S.16 Application No. A/FSS/299

**Application for Minor Relaxation of Plot Ratio and Building Height Restriction
for Permitted Public Housing Development,
Po Shek Wu Road, Sheung Shui, New Territories**

Responses to Comments

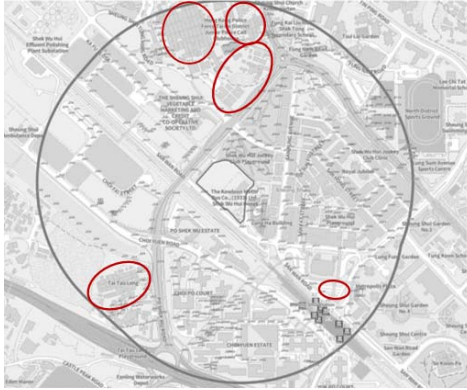
Comments	Responses
<u>Water Services Department (23.8.2024)</u>	
Existing water mains inside the proposed site as shown in the MRP may be affected. The applicant is required to either divert or protect the water mains found on site.	No diversion of water mains is proposed. The water mains found on site would be protected as per WSD's requirement.
If diversion is required, existing water mains inside the proposed site areas are need to be diverted outside the site boundary of the proposed site to lie in Government land. A strip of land of minimum 1.5m in width should be provided for the diversion of existing water mains. The cost of diversion of existing water mains upon request will have to be borne by the applicant; and the applicant shall submit all the relevant proposal to WSD for consideration and agreement before the works commence.	The water mains would not be diverted and would be protected.

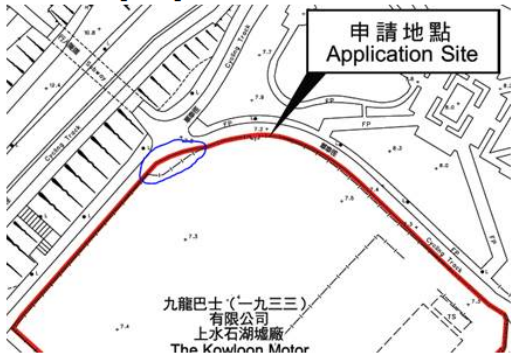
(b) Details of site formation works shall be submitted to the Director of Water Supplies for approval prior to commencement of works.	
(c) No structure shall be built or materials stored within 1.5 metres from the centre line(s) of water main(s) shown on the plan. Free access shall be available at all times for

Comments	Responses
<p>staff of the Director of Water Supplies or their contractor to carry out construction, inspection, operation, maintenance and repair works.</p>	
<p>(d) No trees or shrubs with penetrating roots may be planted within the Water Works Reserve or in the vicinity of the water main(s) shown on the plan. No change of existing site condition may be undertaken within the aforesaid area without the prior agreement of the Director of Water Supplies. Rigid root barriers may be required if the clear distance between the proposed tree and the pipe is 2.5m or less, and the barrier must extend below the invert level of the pipe.</p>	
<p>(e) No planting or obstruction of any kind except turfing shall be permitted within the space of 1.5 metres around the cover of any valve or within a distance of 1 metre from any hydrant outlet.</p>	
<p>(f) Tree planting may be prohibited in the event that the Director of Water Supplies considers that there is any likelihood of damage being caused to water mains.</p>
